Subject: Planned Change Request for the use of Replacement Panels 11 and 12

Planned Change Request
for the Use of Replacement Panels 11 and 12

Planned Change Request for the Use of Replacement Panels 11 and 12

Figure 1. Layout of Proposed Replacement Panels 11 and 12 (NMED 2023)

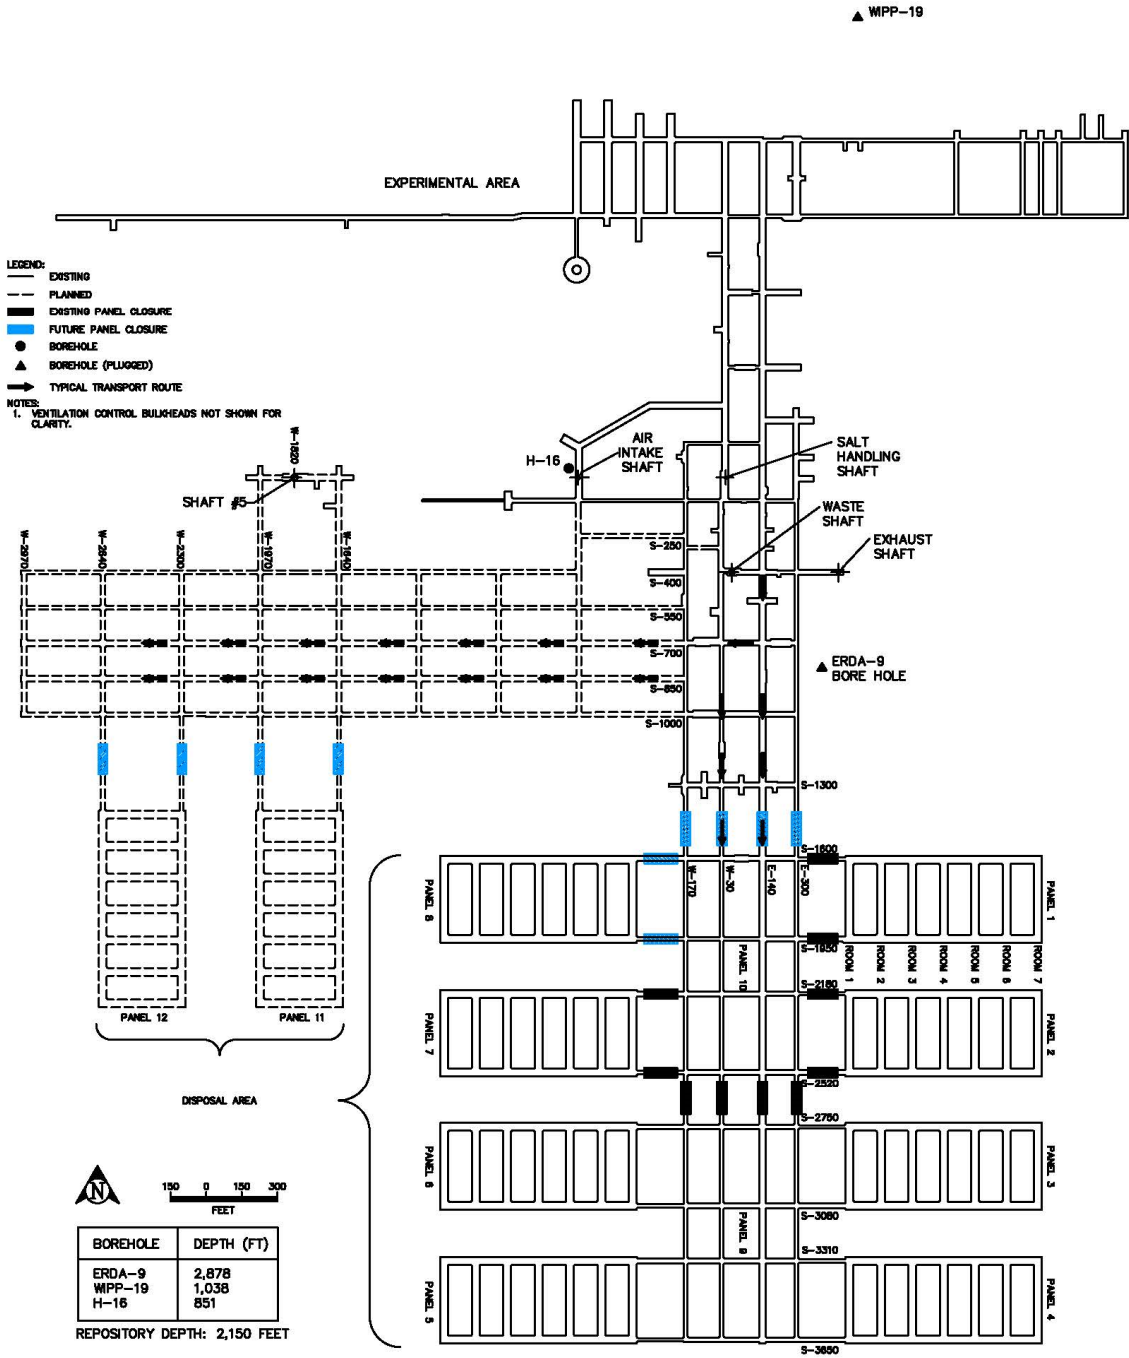
The replacement-panel layout (as illustrated in Figure 1) does not represent the WIPP repository's final configuration at closure, as the DOE has initiated an evaluation of up to seven "additional panels" (for a total of 19 panels) that may be necessary to dispose of the total TRU waste volume capacity limit authorized in the WIPP LWA. If the DOE decides to pursue the proposed action to construct and use additional panels, a future Planned Change Request (PCR) with the additional panel layout will be submitted to the EPA for review and approval.

The design for replacement Panels 11 and 12 is similar to Panels 1 through 8 (i.e., seven disposal rooms per panel). Replacement Panel 11 will be located to the south of the west mains at W-1640 and W-1970, and replacement Panel 12 will be located at W-2300 and W-2640 (Figure 1). Both replacement Panels 11 and 12 will be located within the same stratigraphic geologic horizon as Panels 1 through 8, approximately 2,104 feet (641 meters) below the surface.

Figure 2. Proposed Repository Layout (NWP 2020)

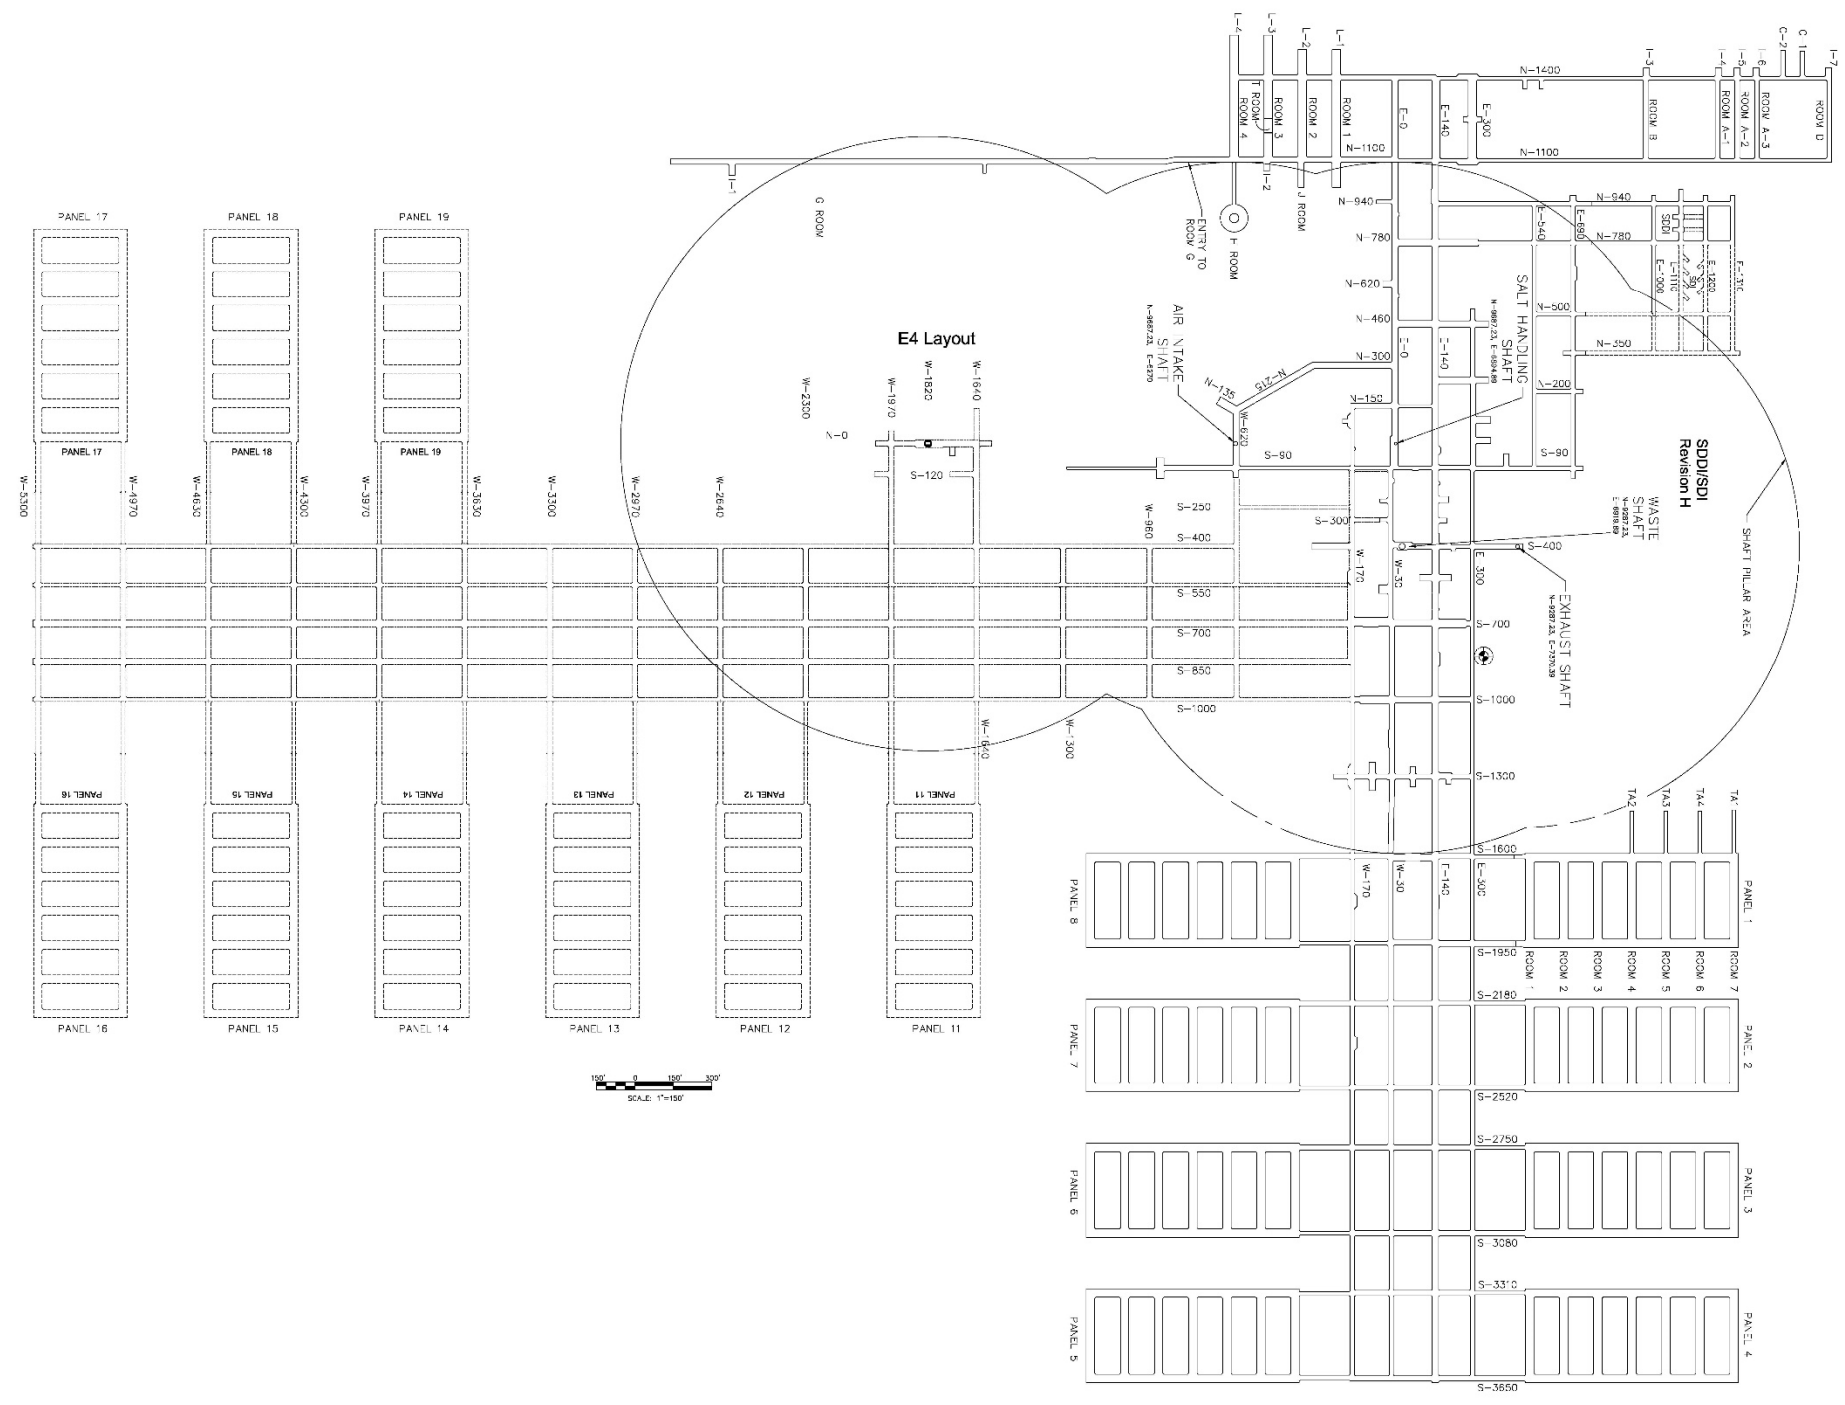
The repository is assumed to be filled to the LWA volume capacity limit by placing waste in the replacement Panels 11 and 12 and the additional Panels 13 through 19 (Figure 2). The assumption for a final facility closure date of 2083 is derived from the latest date a generator site plans to generate TRU waste (U.S. DOE 2022a). The DOE recognizes that there is uncertainty associated with a definitive closure date, and the generator-site completion dates for waste generation will evolve over the projected operational life of the WIPP facility (i.e., between now and 2083).

Figure 4. Example Active Institutional Controls Perimeter Fence Line and Roadway and Passive Institutional Controls Marker System Footprint (NMED 2023)

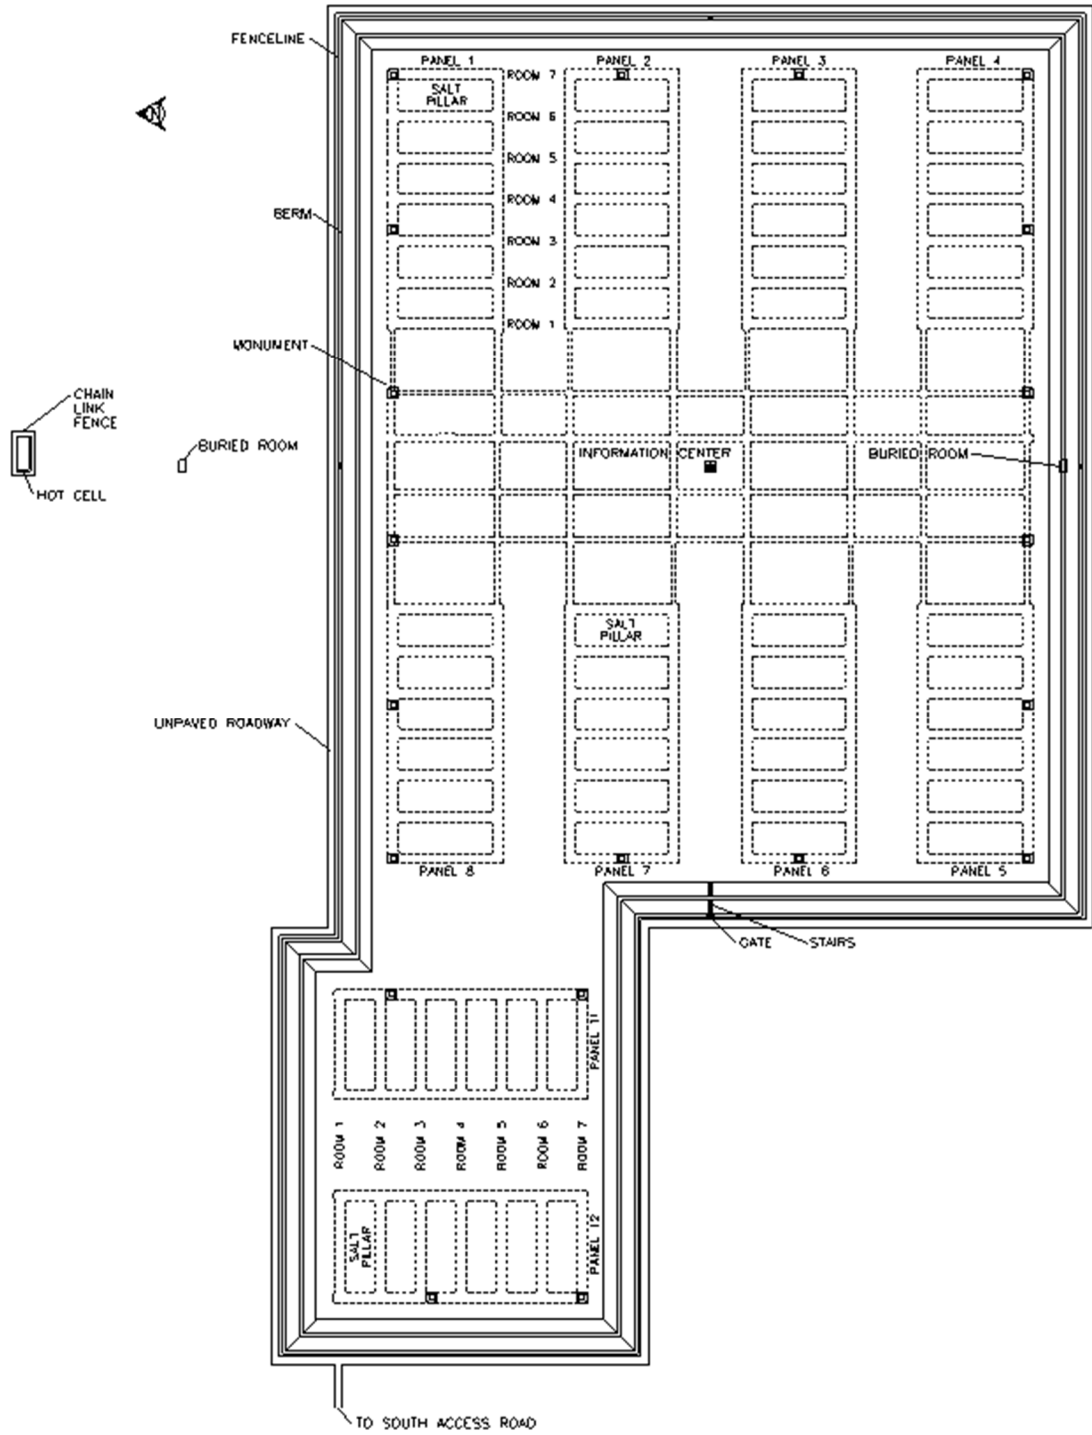
There are currently no plans to close the WIPP facility after Panel 12 is filled. The DOE plans to emplace defense-generated TRU waste up to the WIPP LWA volume capacity limit of 6.2 million cubic feet (175,564 cubic meters). The DOE proposes that continued compliance with the criteria of 40 CFR 194.41 would be achieved by extending the current Active Institutional Control (AIC) approach over the surface expression area for any added footprint. The fenced

Relative to Passive Institutional Controls (PICs), the DOE similarly proposes that continued compliance with the criteria of 40 CFR 194.43 would be achieved by the extension of the placement markers over any added footprint. Such markers will be constructed in a manner that will make them as permanent as practicable and able to withstand both natural and human-initiated forces that would be reasonably expected to occur at the site.

Figure 2-1. Current Repository Footprint and Proposed Replacement and Additional Waste Panels

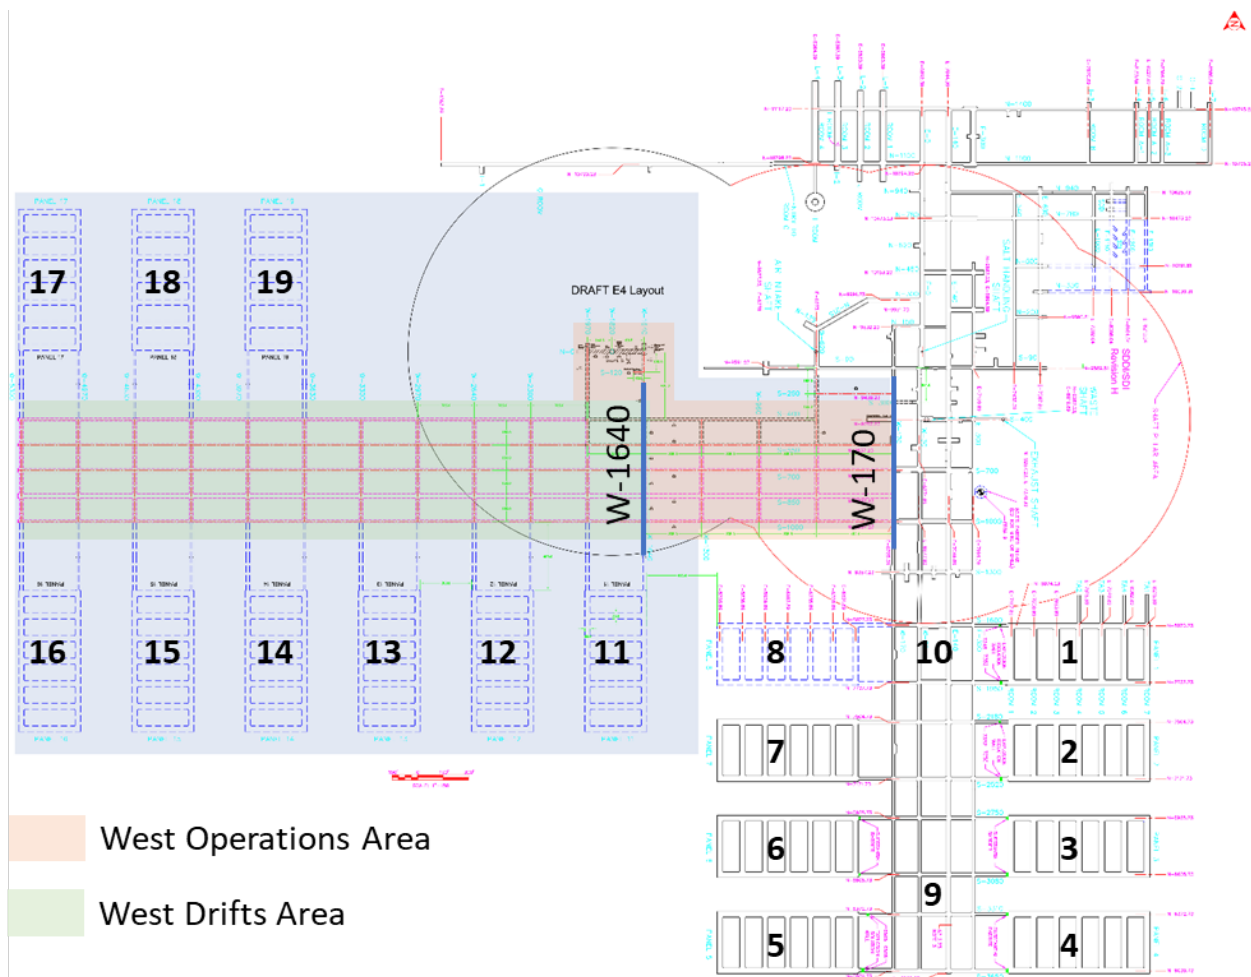
The DOE plans to excavate additional volume for waste disposal, comprising two replacement waste panels (numbered 11 and 12) and potentially seven additional panels (numbered 13 to 19) to the west of the current repository footprint (Figure 2-1, adapted from Sjomeling 2019). In the design used for this analysis, Panels 11 through 19 are similar to Panels 1 through 8, except that the abutment pillars (between the waste rooms and the access drifts) are increased from 61.0 m (200 ft) to 122.0 m (400 ft) and the isolation pillars (separating two panels) are increased from 61.0 m (200 ft) to 91.5 m (300 ft).
